SITE PLAN FOR PLANNING COMMISSION
EXISTING CONDITIONS

1201, 1209, 1213 SOUTH UNIVERSITY
CITY OF ANN ARBOR FILE #SP24-0020

SITE PLAN FOR PLANNING COMMISSION
SITE LAYOUT PLAN

L1.100

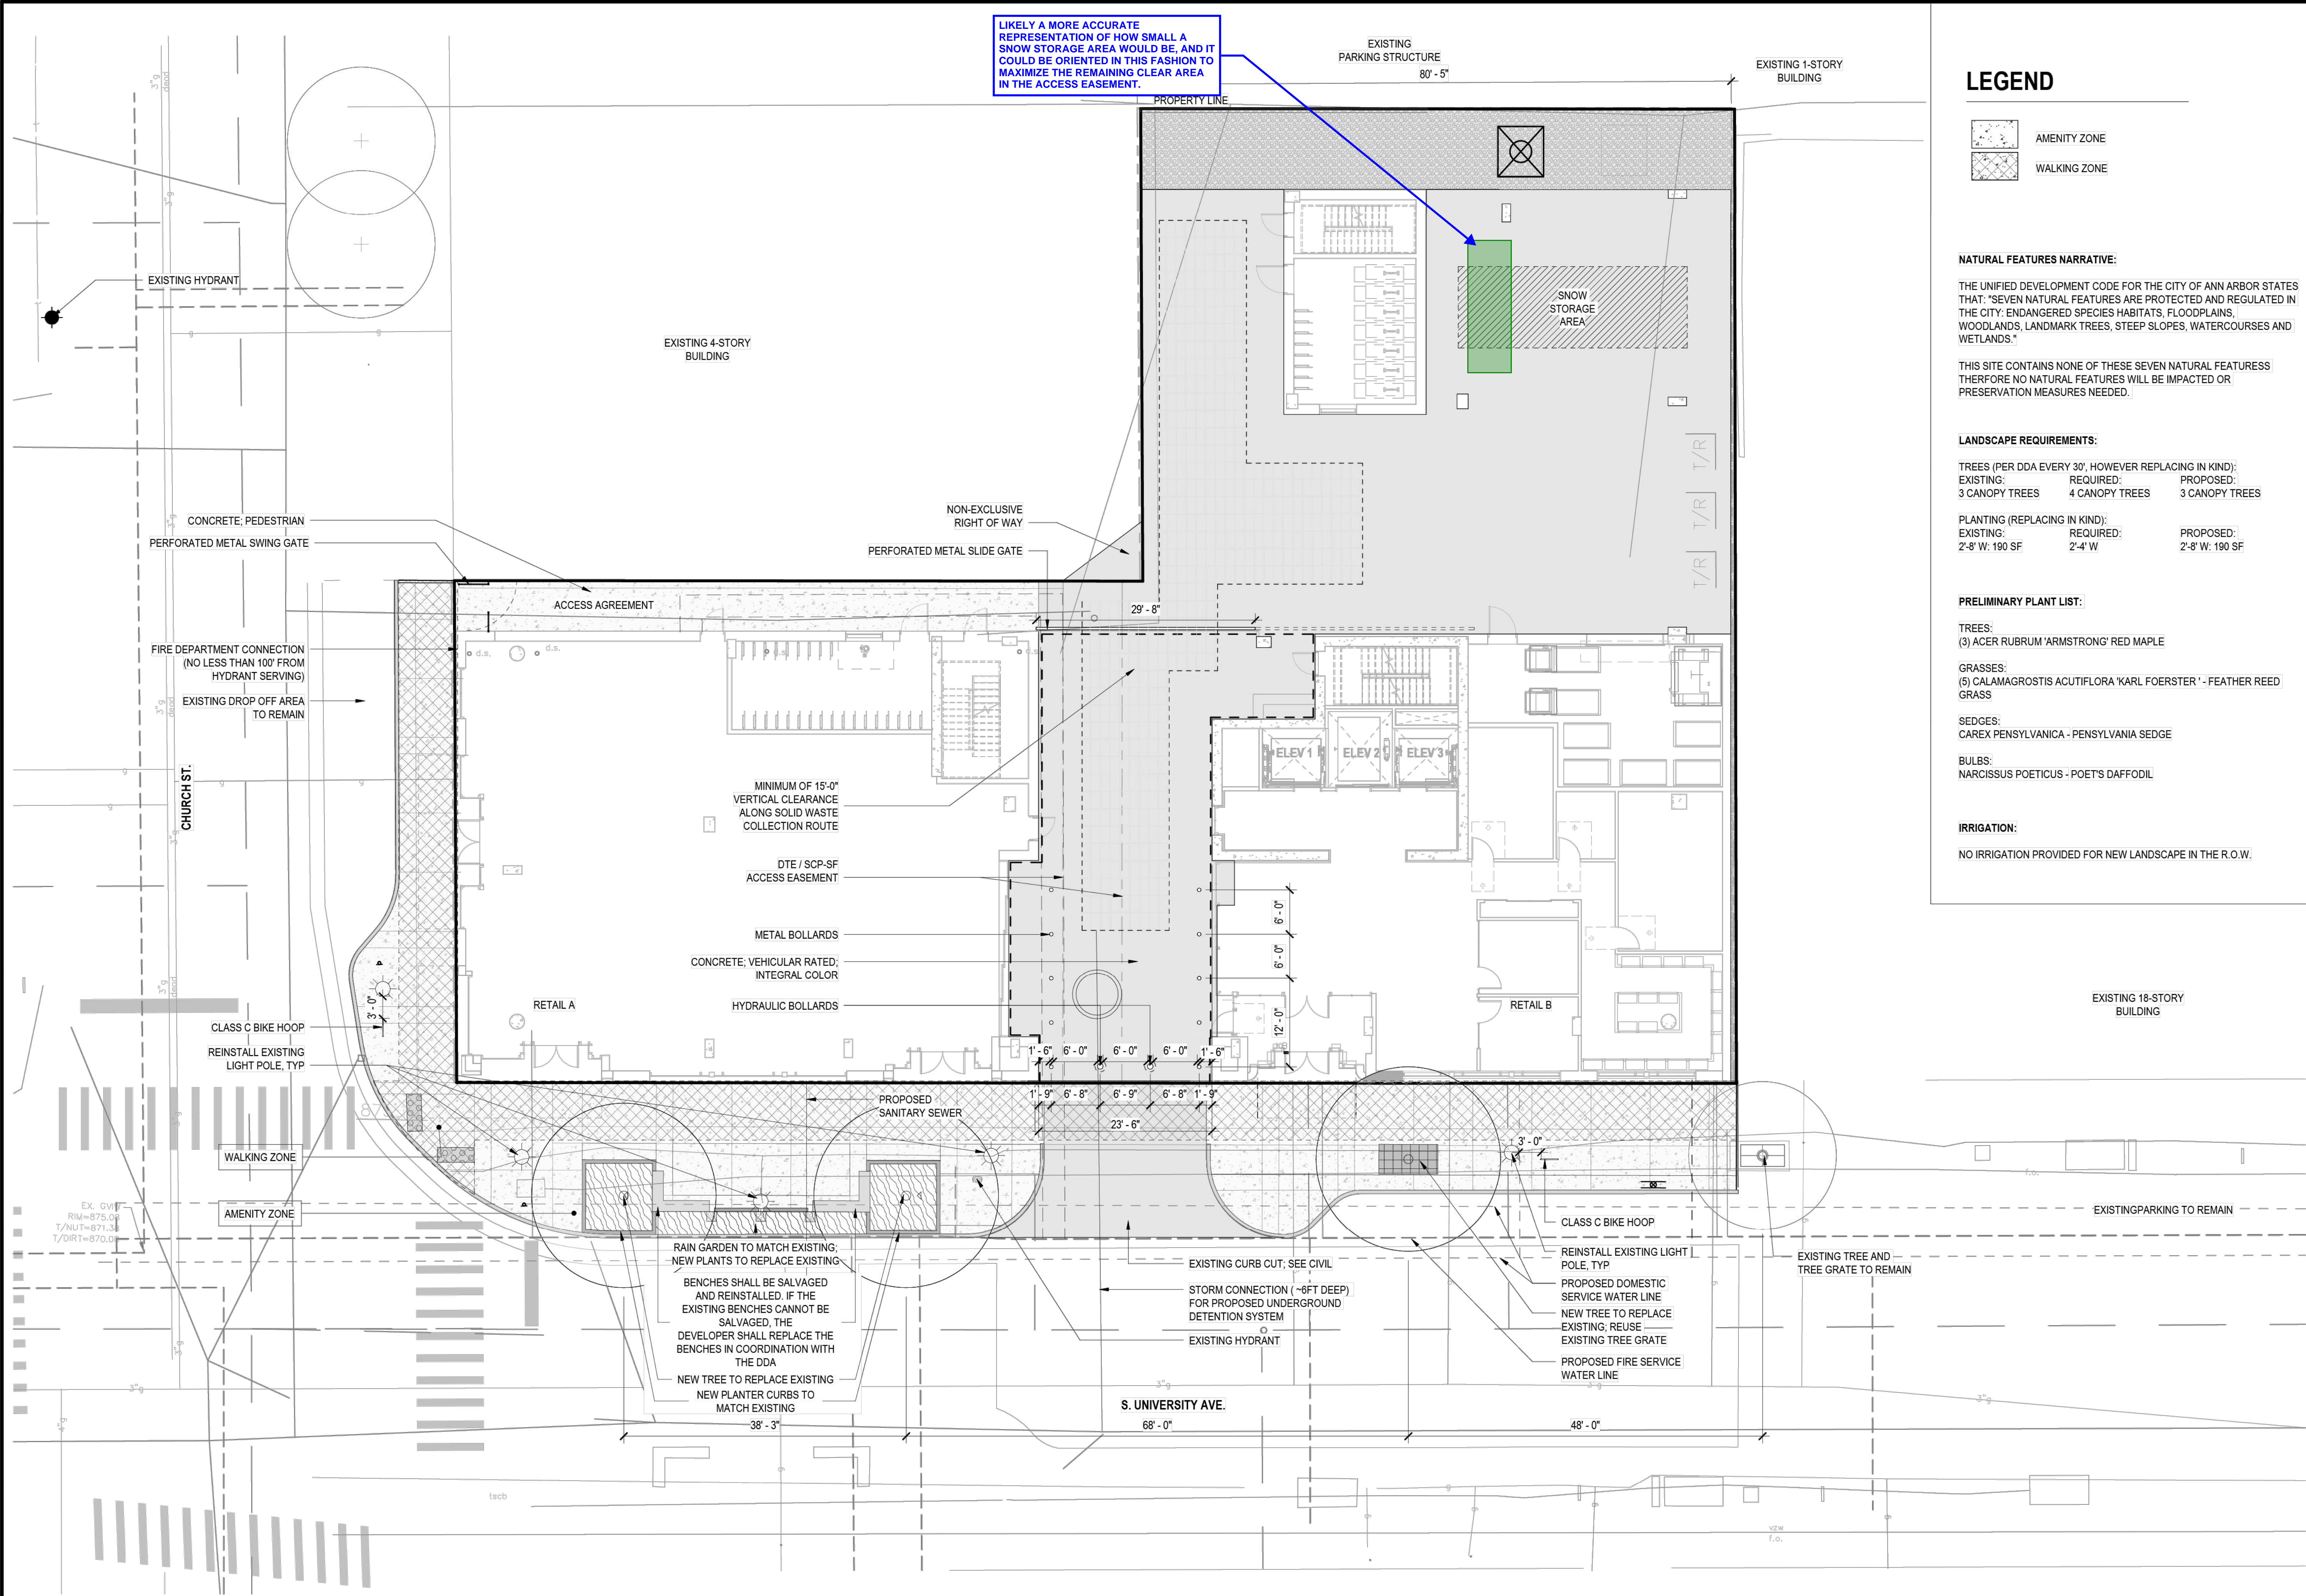
- The Proposed Development illustrates a "Snow Storage Area" directly in the middle of the northernmost portion of the access easement (see page L1.100 of the Site Plan). This would be a complete obstruction to access to the SCP-SF parcel in the winter months.

LIKELY A MORE ACCURATE REPRESENTATION OF HOW SMALL A SNOW STORAGE AREA WOULD BE, AND IT COULD BE ORIENTED IN THIS FASHION TO MAXIMIZE THE REMAINING CLEAR AREA IN THE ACCESS EASEMENT.

CHAPTER ANN ARBOR
SITE PLAN FOR PLANNING COMMISSION
UTILITY PLAN

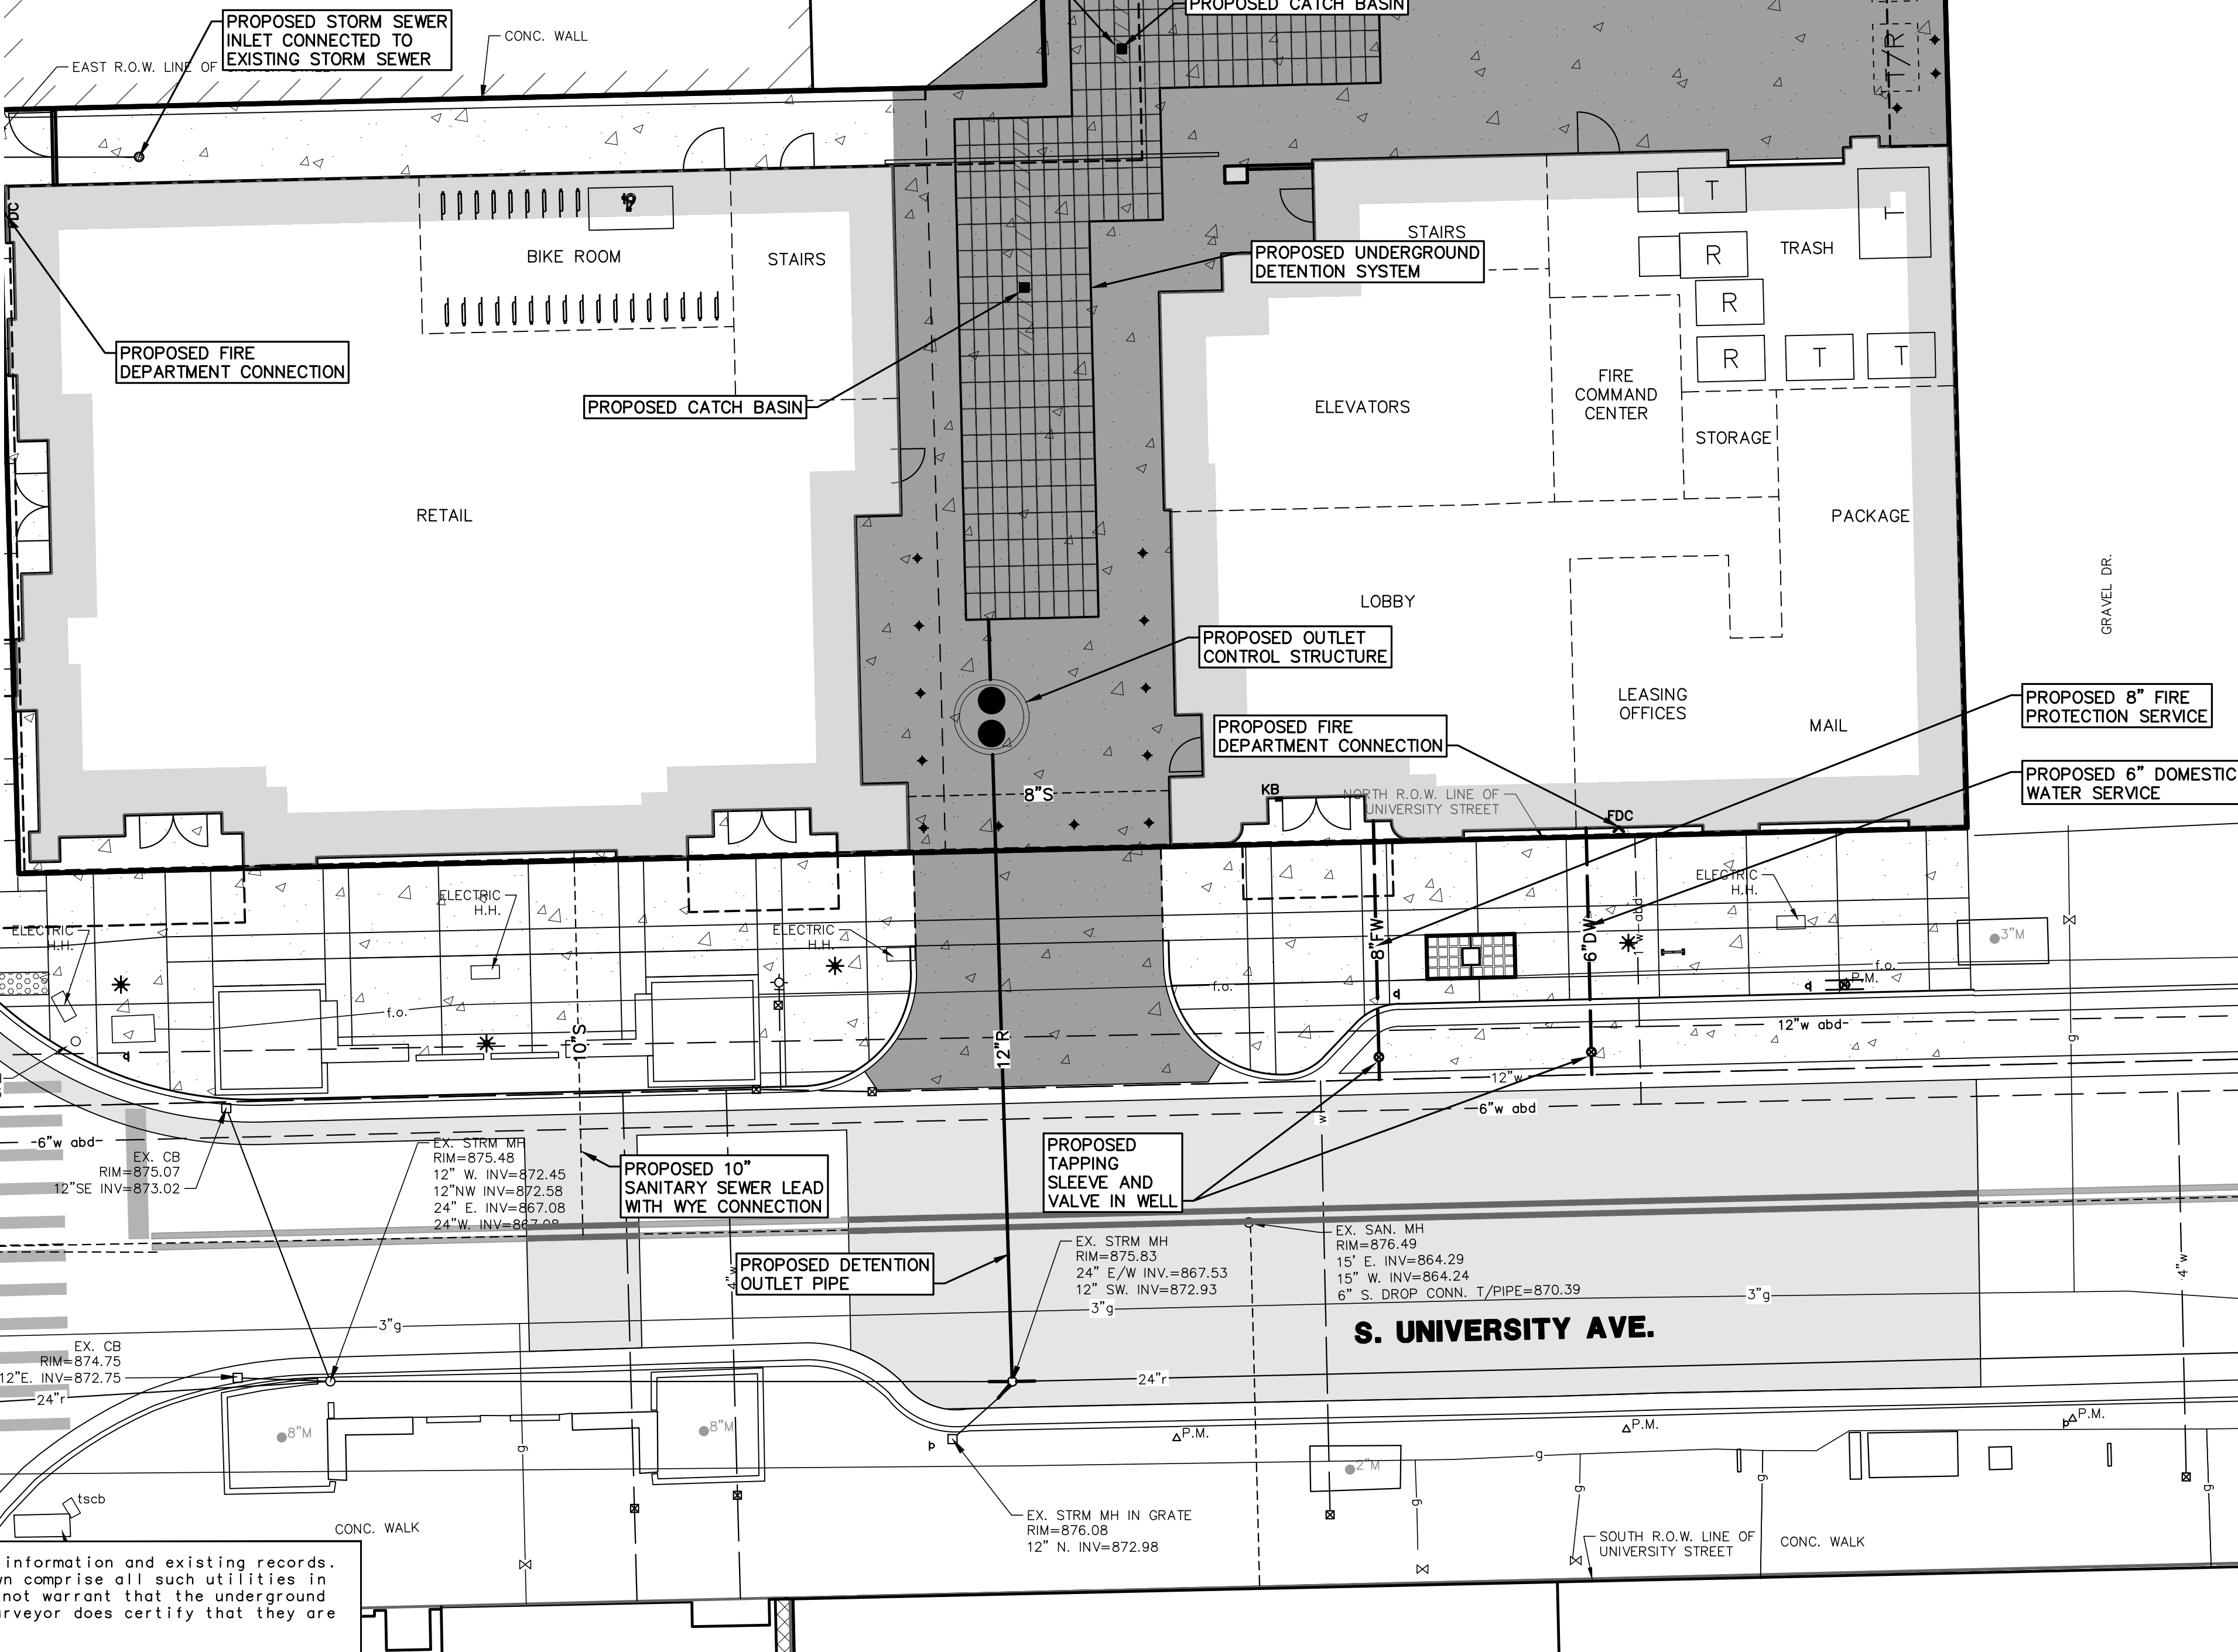
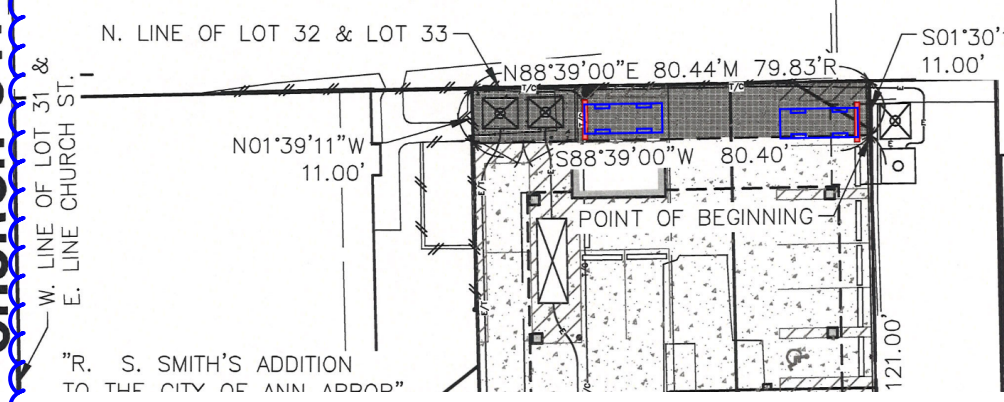
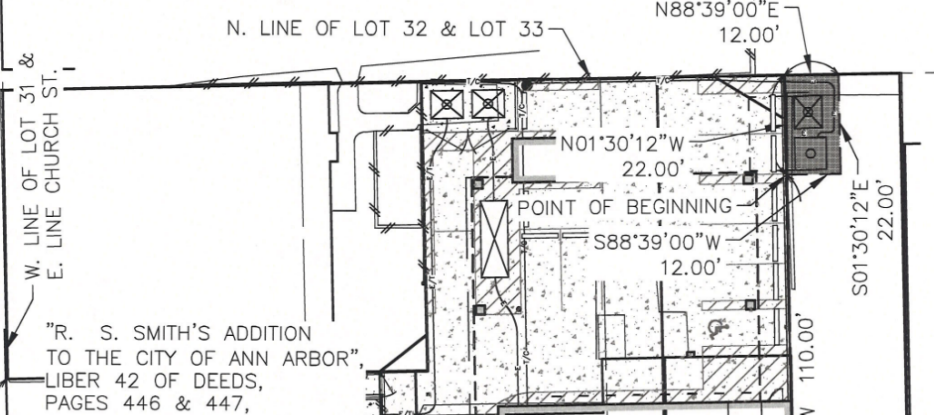
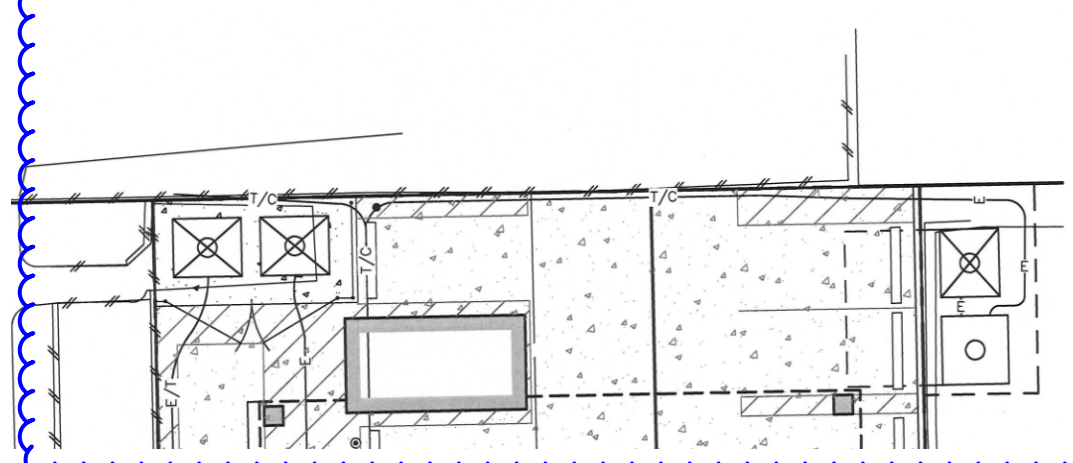
The Proposed Development illustrates a "Proposed Transformer" within the SCP-SF utility easement that differs completely from that agreed upon in the Easement Agreement. See page 10 of the Site Plans. SCP-SF has not been approached by the developer or DTE about changing the agreed upon placement of transformers and equipment in its utility easement.

THE TRANSFORMERS SHOWN AT THE TIME THE EASEMENT AGREEMENT WAS DEVELOPED REPRESENTS A CONFIGURATION THAT WAS SUFFICIENT FOR THE PREVIOUS DEVELOPMENT, AND WITHOUT THE BENEFIT OF HAVING FULLY COORDINATED WITH DTE TO UNDERSTAND THEIR NEEDS AND PREFERENCES. IN THE TIME SINCE THE AGREEMENT WAS EXECUTED, DTE DESIGNED AND PLANNED FOR THE INSTALLATION OF NEW INFRASTRUCTURE (SWITCH CABINET) ON THE SUNE PROPERTY. TO OUR KNOWLEDGE, THE SWITCH CABINET THAT HAS SINCE BEEN INSTALLED ON THE SUNE PROPERTY CURRENTLY SERVES A NUMBER OF PROPERTIES IN THE AREA, AND HAS CAPACITY TO SERVE THE SCP-SF PROPERTY) IS THE SWITCH CABINET THAT WAS CONTEMPLATED TO BE INSTALLED ON THE SCP-SF PROPERTY AS SHOWN IN EXHIBIT E-2
